Application for Plan Review

Name of Project Pool House

February 6, 2012

Trotter's Ridge Community Pool

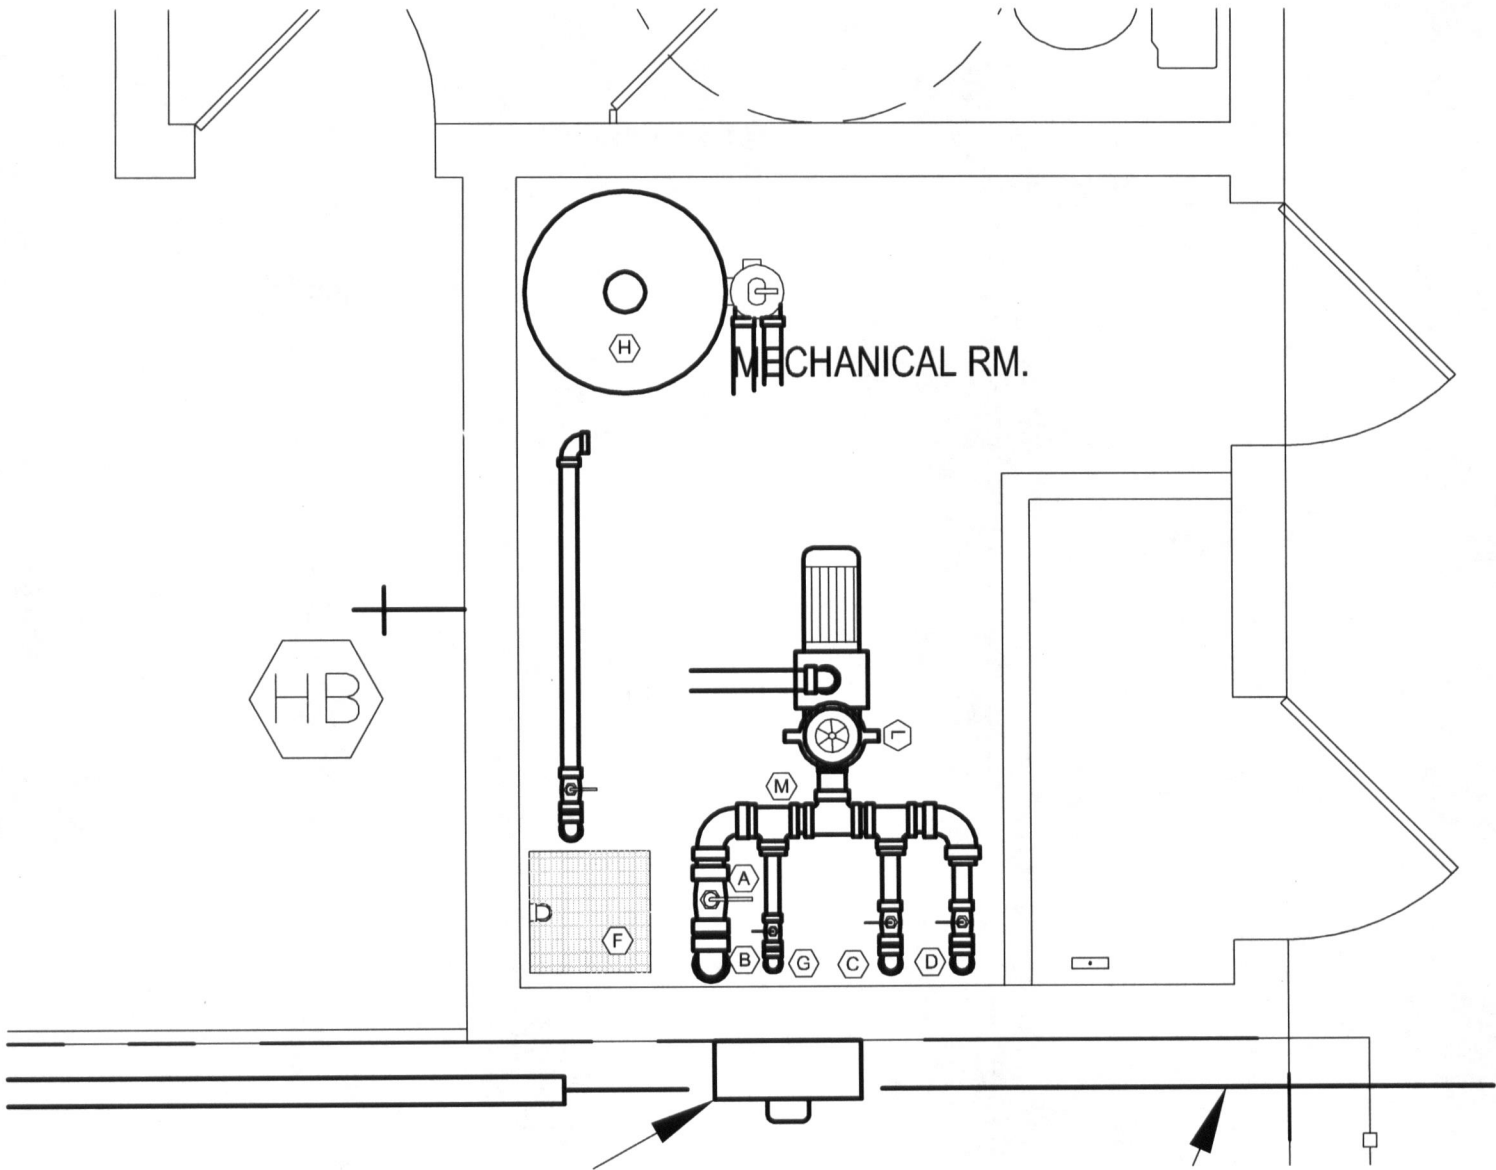
- **906.1 Fire Extinguishers**
 - Fire extinguishers shall be placed in approved locations as drawn by the code enforcement official on the approved plans.
 - The fire extinguishers provided shall have a minimum rating of 2A 10B:C and shall not be installed higher than 5 feet above the finished floor
 - As noted on plans
